# Field Cage Endwall G10 Alignment Strip

on behalf of the LSU FC endwall team

# FC Endwall Alignment Strip

G10 Alignment Strip

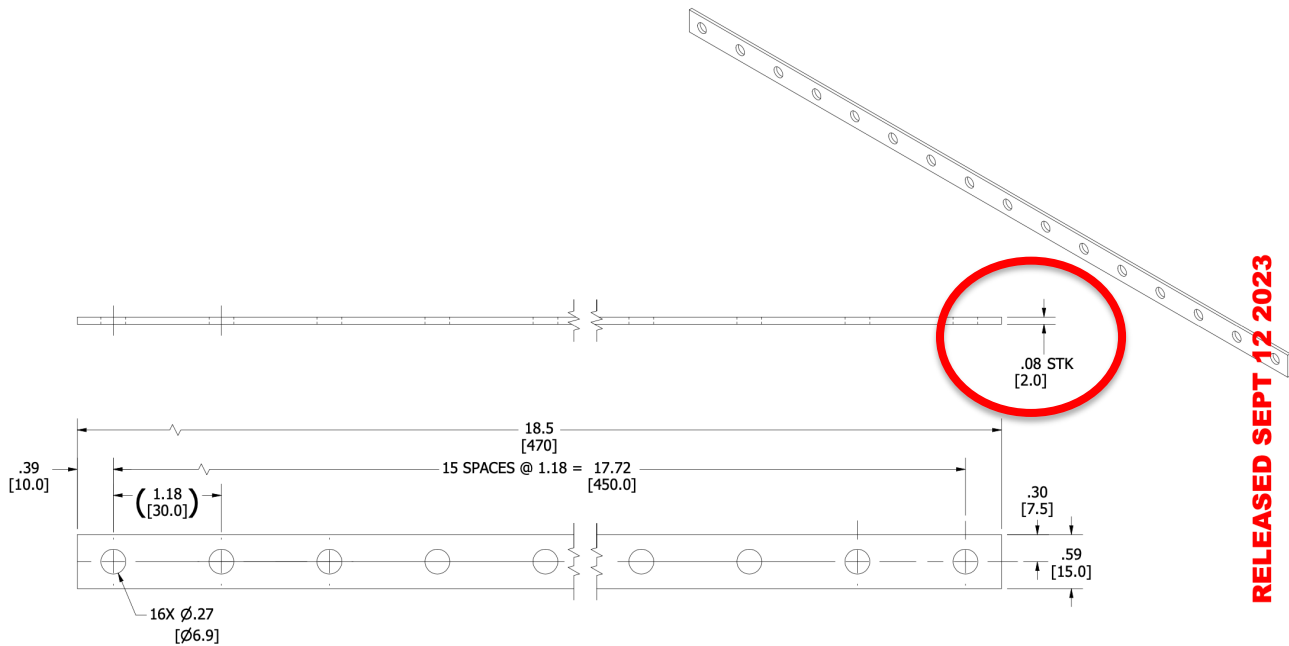
Readily available G10 sheets in US:  
**1/16" (= 1.59 mm) or 3/32" (= 2.38 mm)**

# FC Endcap Rivet and Profile

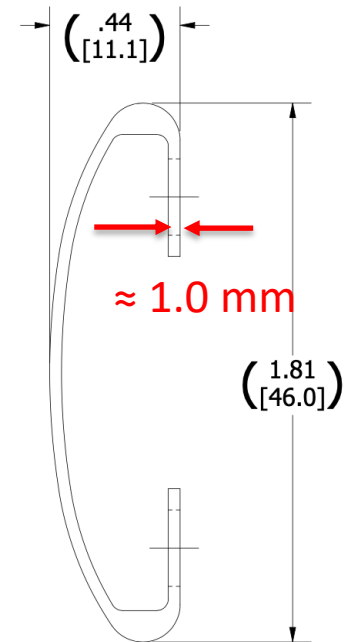
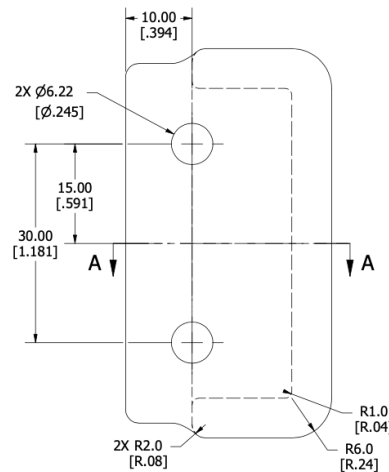
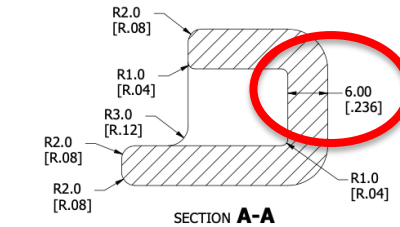
≈ - 0.11 mm

# FC G10 strips, Endcap, Rivet, Al Profile

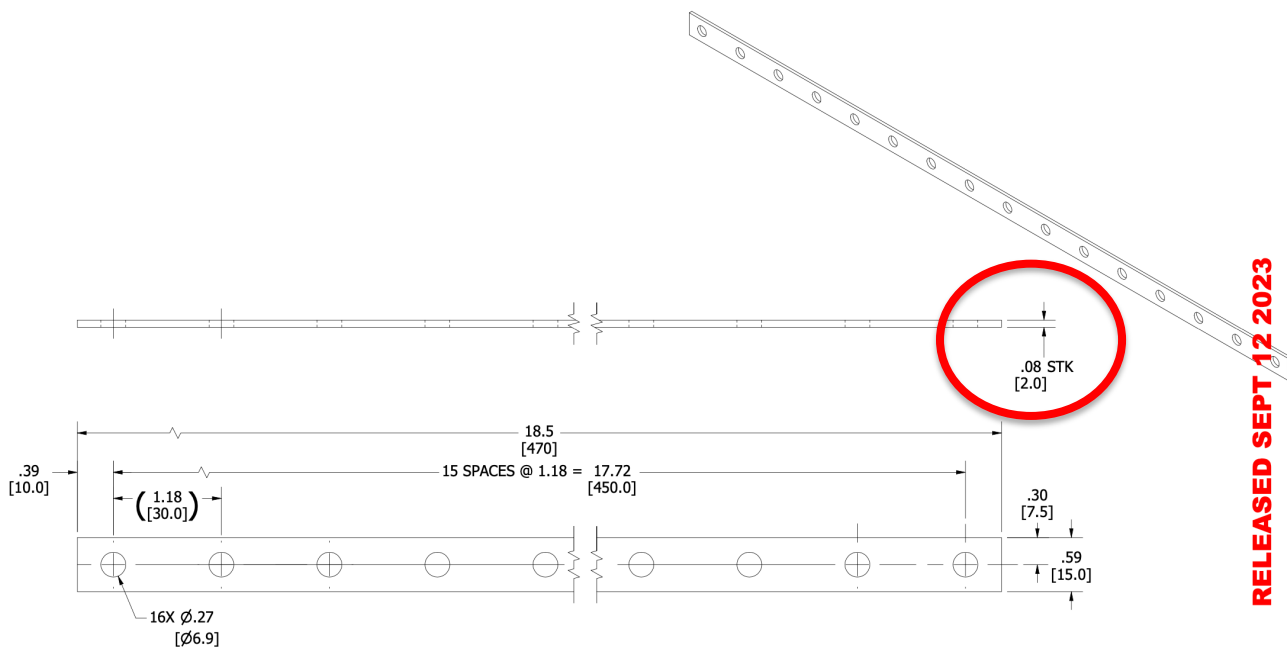
➔ Rivets engage easily and lead to reliable attachment of G10 Alignment Strip
